**HECO IGP Technical Advisory Panel
Summary and Feedback from May 2022 Meeting
06/05/2022**

This feedback and summary was delivered by the IGP Technical Advisory Panel (TAP) to Hawaiian Electric (HECO) based on HECO's slides and presentation at the full TAP meeting on May 4 and 5, 2022.

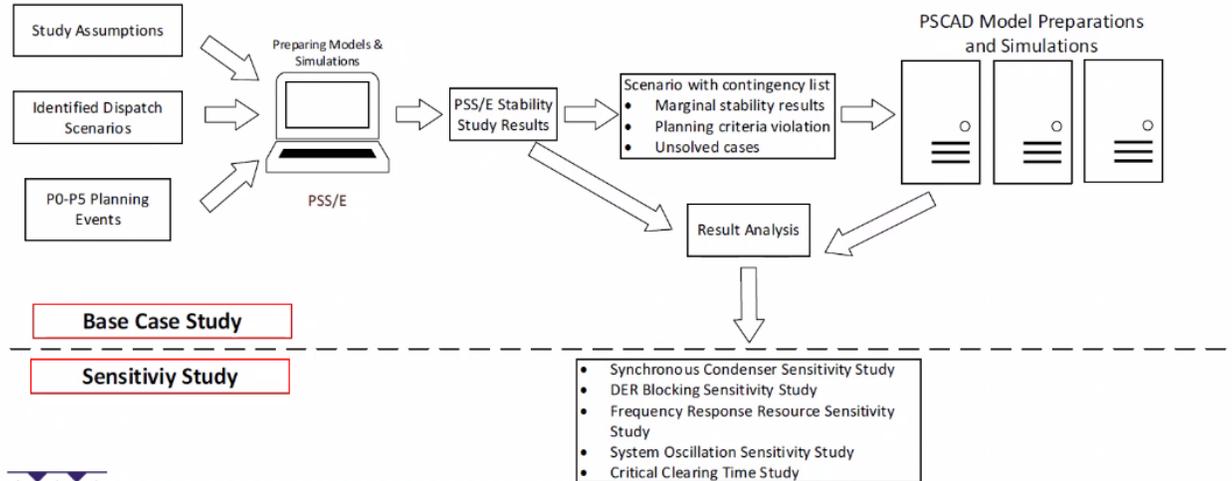
- TAP: Is that related to distribution protection?
- HECO: Transmission planners are running PSCAD models. A 3-phase fault is assumed to clear in 2 seconds. A high-impedance SLG fault is assumed to clear in 20 seconds.

- TAP: Have you tried to make sure the protection will clear in worst-case fault current scenarios?
- HECO: Relays can be adjusted to improve clearing with low fault current. Fuses are harder to adjust. Could reduce distribution transformer impedance to increase fault current.

- TAP member: If you have sufficiently high voltage during faults, does that mean you have sufficient fault current for protection?
- Other TAP member: Not necessarily. Others agree.

- HECO: In the transmission study, voltage dips for distribution faults remain local.
- TAP feedback: [Protection needs for very high-IBR systems are a difficult question. We can take it to the TAP T or D subcommittees for further discussion.](#)

Relative Range of Stability Support by Resource Type

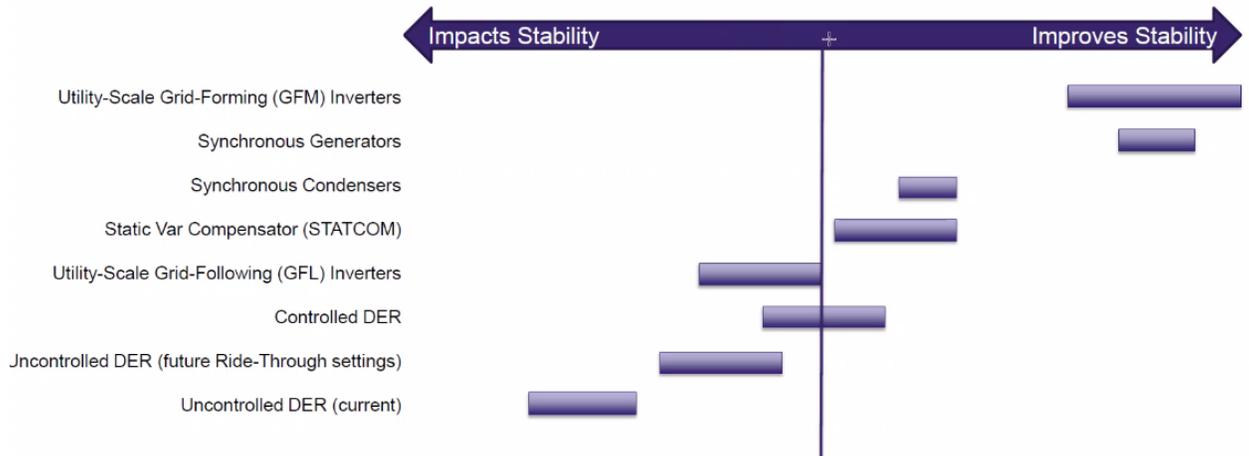
- - The first GFM project will likely be KES (on Oahu). The others are likely delayed.
 - The PSCAD study shows that syncons only provide good voltage support close to the syncon.
 - TAP: Let's look in more detail at this chart in T subgroup.
 - TAP: Surprised to see SC has much less stability benefits than SG. HECO: The PSCAD study shows that active power is needed for system recovery following DER MC and trip events.
 - TAP: Please define grid-forming and grid-following along with this chart.
 - HECO: Here, "GFM" means the specific dynamic behavior of stage II projects in this study.

- TAP: A GFM inverter could also use momentary cessation (MC).
 - HECO: MC has not been seen from GFM in the PSCAD study. MC is not allowed per the stage 2 PPA. However, models are known to sometimes miss MC.

- HECO: Field data shows a big MC issue with large GFL projects.
 - TAP: Does PPA for GFLs prohibit MC? Probably a GFL could also be designed to avoid MC.

- HECO: Older PPAs allowed MC in limited circumstances. The models for these IBRs don't show MC, but the real projects do use MC in field. So, we don't fully trust the models.

- TAP: Yes, lack of accurate IBR models is an industry-wide problem.
 - HECO: This diagram is very generalized, and linked to this specific PSCAD study.

- HECO: We have seen ROCOF up to 7 Hz/s on 100 ms windows in the PSCAD study. We are concerned about DER responses to that.
 - TAP: We agree this is a system stability concern, and DER behavior at very high ROCOF is unknown. The NREL study that HECO is sponsoring will shed some light on how DERs will respond to high ROCOF and other transients.

- HECO: We will update the PSCAD DER models based on that study when results become available.

Probabilistic Resource Adequacy Results

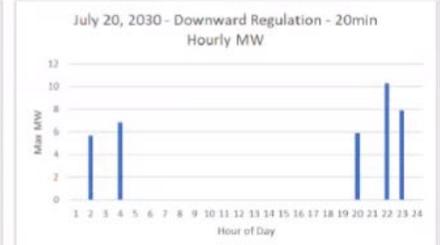
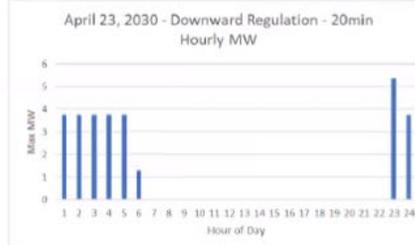
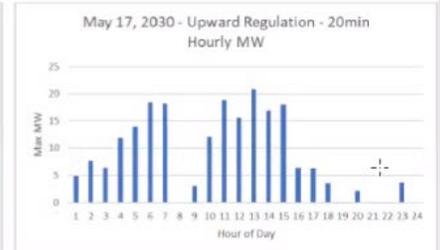
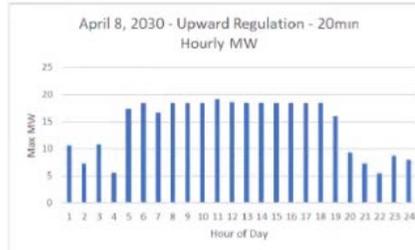
- The TAP and HECO agree there is no correlation between weather and thermal forced outages in HNEL analysis or HECO’s analysis because Hawaii does not have extreme high or low temperatures.
- The TAP and HECO need to focus on distinguishing what questions we need to answer now before procuring the next round of resources, vs what can we improve in the future to guide future procurements.
